HISTORIC AND DESIGN REVIEWCOMMISSION

HDRC CASE NO: 2021-033

ADDRESS: 324 E ROSEWOOD AVE

TYPE OF WORK: Roof replacement APPLICATION RECEIVED: January 07, 2021

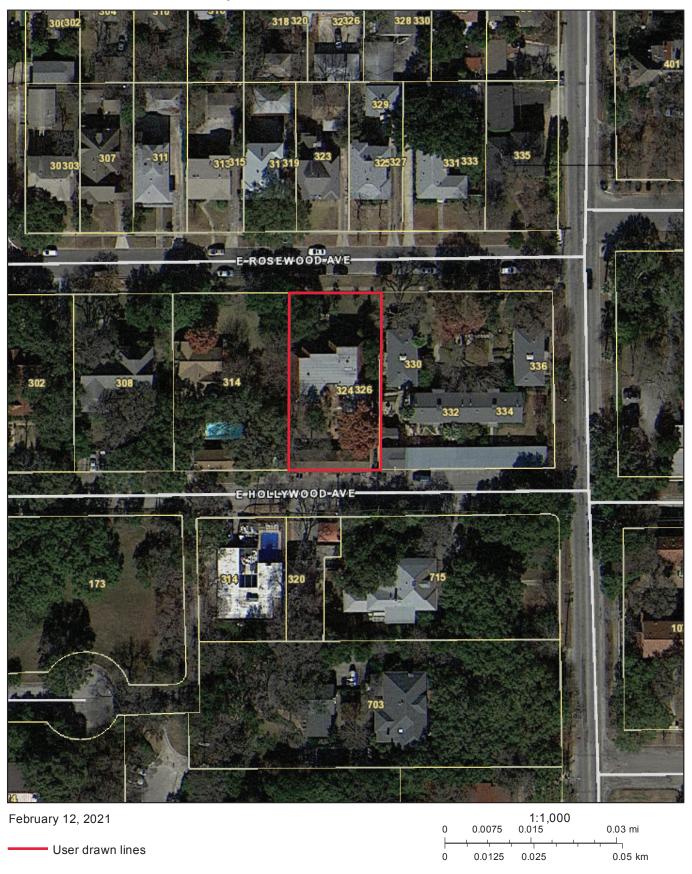
a. The primary structure located at 324 E Rosewood is a 2-story, multi-family structure constructed circa 1930. It first appears on the 1951 Sanborn map. The structure has an asymmetrical u-shape plan and features a flat roof with mansard slopes and red clay or ceramic tiles, a pitched tile porch roof, a secondary front gable porch awning, a stone veneer, and one-over-one windows. The property is contributing to the Monte Vista Historic District.

b. The applicant has proposed to replace the existing red clay or ceramic tile roof with a composition shingle roof to match other stone veneer properties on the block. Guideline 3.B.iv for Exterior Maintenance and Alterations states that roofing materials should be replaced with in-kind materials whenever possible when the roof must be replaced. Historic materials such as slate or clay tiles should be retained and re-used when large-scale replacement of roof materials other than asphalt shingles is required. The existing clay roof tiles are severely damaged and require replacement. Furthermore, Guideline 3.B.iv states that new roofing materials should match the original materials in terms of their scale, color, texture, profile and style or materials should be selected that are consistent with the building style when in-kind replacement is not possible. The 1951 Sanborn map shows that the original roof was composition; however, the Sanborn map may have referenced the material of the flat roof portion of the structure. Staff finds the request is inconsistent with the Guidelines. Staff finds that the installation of a material, such as pressed metal, that is similar in appearance to the existing tile would be appropriate.

Staff does not recommend approval based on findings a through b. Staff recommends that the roof is replaced with in-kind materials or a material similar in appearance to the existing tile.

If the HDRC finds roof replacement with composition shingles appropriate, staff recommends the following stipulations:

- i. That the replacement composition shingles are similar in appearance to the existing tile and are verified by staff. The applicant is required to submit final material specifications to staff for review and approval.
- ii. That the applicant maintains the existing ridge detailing.
